RE: Cover Letter for Peer Review Comments on for Modera Weston

Re: Modera Weston – 751-761 Boston Post Road, Weston, MA

Howard Stein Hudson (HSH) has received the review comments prepared by MetroWest Engineering, Inc. dated August 7, 2019 (the “Review Letter”) regarding the Modera Weston Project located at 751-761 Boston Post Road. We offer the following responses to the detailed review comments starting on Page 3 of the Review Letter:

Figure 1. Existing Conditions

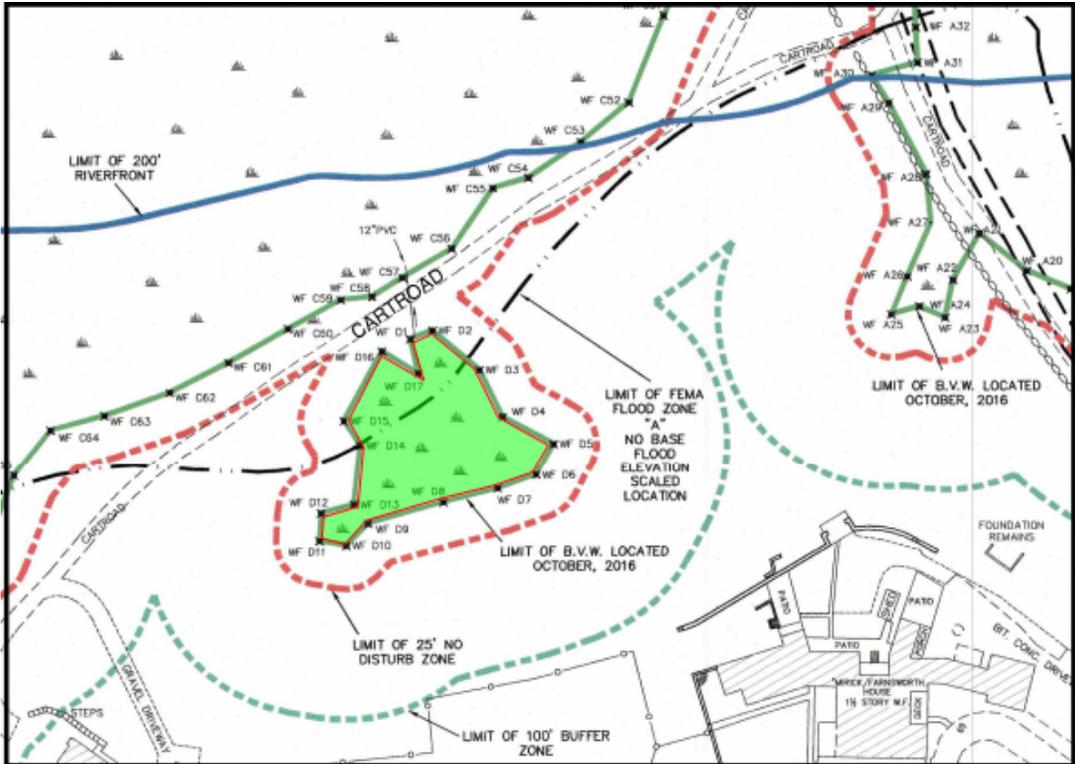
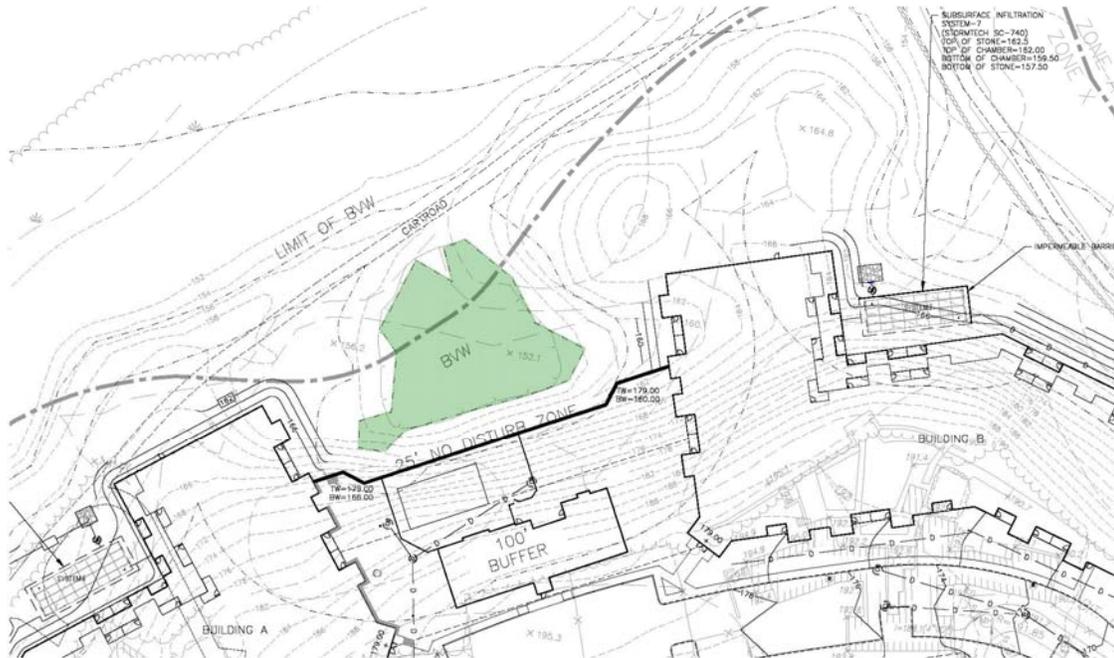
More recently, in response to concerns raised by direct abutters, we have relocated the majority of the amenity programming, particularly the outdoor amenity programming, from its initial position at the southerly portion of the site along Boston Post Road to the area between the two mid-rise buildings located on the northerly side of the development area. That move creates an extensive buffer between the active amenity center and the neighbors. However, relocating the amenity center to this new location did create a pinch-point at a nearby wetland. It should be noted that the wetland area in question was initially a borrow pit for gravel used during the early development of the farm and is "cut off" from the main wetland area by an existing active Cart Road. (See Figures 1 and 2.)

Together, this is a significant impact reduction on the overall property as compared to the initial concept that proposed development on both major upland parcels with a wetland & stream crossing for the access roadway. The proposed project has been designed to avoid adverse impacts to the downgradient Wetland Resource Areas.

Figure 3. Water Level at Depression

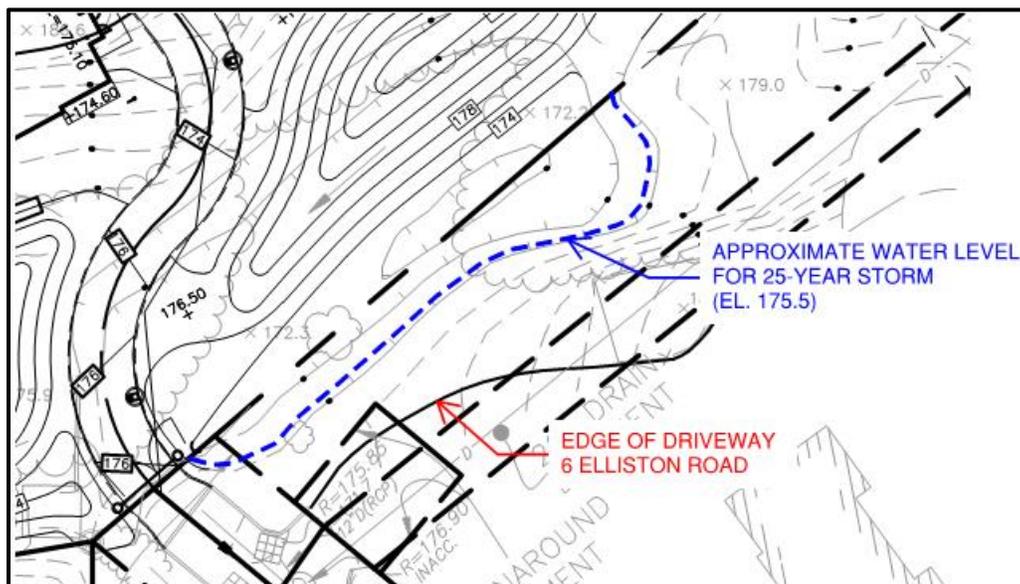
3. The landscaping berm to the east of the Elliston Road extension fills a substantial portion of an existing depression, referred to in the design documents as the “Southeast Depression”. This depression straddles the boundary line between the subject property and property at 6 Elliston Road. At present, this depression serves as a stormwater collection and storage basin for about 3-acres of the locus. More importantly, this same depression collects and stores stormwater for several acres of property that is off-locus, including runoff from Elliston Road, properties at 3, 4 and 6 Elliston Road and properties at 741 and 745 Boston Post Road. All of these properties flow into the “Southeast depression”. The proposed grading plan (construction of the landscaping berm) eliminates about 60 percent of the stormwater storage volume in this depression. This grading scheme therefore has the potential to displace stormwater from the locus and onto the property at 6 Elliston Road, thereby damaging that property. This topic will be discussed in greater detail in the section of this report that discussed the hydrologic model and hydrologic impacts.

Response: The calculations have been revised to include off-site areas. The low point of the depression overlaps the property line between the Project Site and 6 Elliston Road. The peak elevation in the depression increases slightly in proposed conditions for the 2, 10, and 25-year storm events, but water levels remain near the property line and do not reach the driveway of 6 Elliston Road (see Figure 3). We are continuing to evaluate this area to further improve conditions.

The peak elevation in the depression decreases slightly in the proposed conditions for the 100-year storm event. This is the result of setting the overflow from the depression at Elevation (EL.) 175.50'. This overflow is directed to the wetlands within the Project Site.

The emergency access has been re-graded to include a high point between Elliston Road and the proposed Townhomes so major storm events will not back up from the depression and flow towards the Townhomes.
